SUNDRY NOTICES AND REPORTS ON WELLS (DO NOT USE THIS FORM FOR PROPOSALS TO DRILL OR DEEPEN OR PLUG BACK TO A DIFFERENT RESERVIOR. USE "APPLICATION FOR PERMIT" (FORM C-101) FOR SUCH PROPOSALS.)		WELL API NO. 30.015.01584

2. Name of Operator Apache Corporation		6. State Oil & Gas Lease No.
3. Address of Operator 303 Veterans Airpark Lane, Ste. 3000, Midland, TX 79705		7. Lease Name or Unit Agreement Name Empire Abo Unit (309164)

LEASE NAME	Empire Abo Unit
WELL #	#035
API #	30.015.01584
COUNTY	EDDY, NM

PROPOSED PROCEDURE

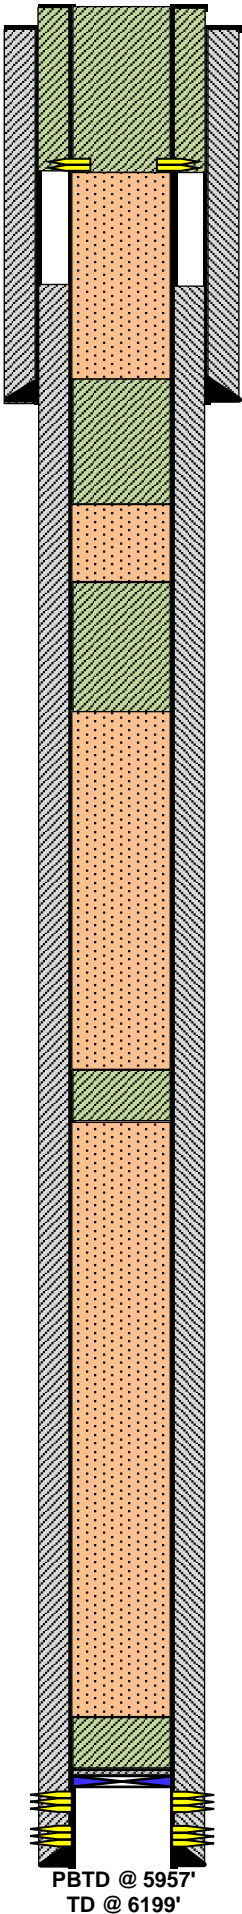
5. PUH & perf @ 300' & sqz 90 sx Class "C" cmt from 300' to surf. Attempt to CIRC 4 1/2" to surf. (Water Board & Surf Plug)

4. PUH & spot 45 sx Class "C" cmt from 1580'-952', WOC/TAG (Gloreita, Queen, & Surf Shoe)

3. PUH & spot 25 sx Class "C" cmt from 2102'-1752', WOC/TAG (San Andres)

2. PUH & spot 25 sx Class "C" cmt from 3615'-3265', (Yeso)

1. MIRU P&A rig, RIH & verify CIBP @ 5957', CIRC w/ MLF & spot 25 sx Class "C" cmt from 5957'-5607', (Abo)
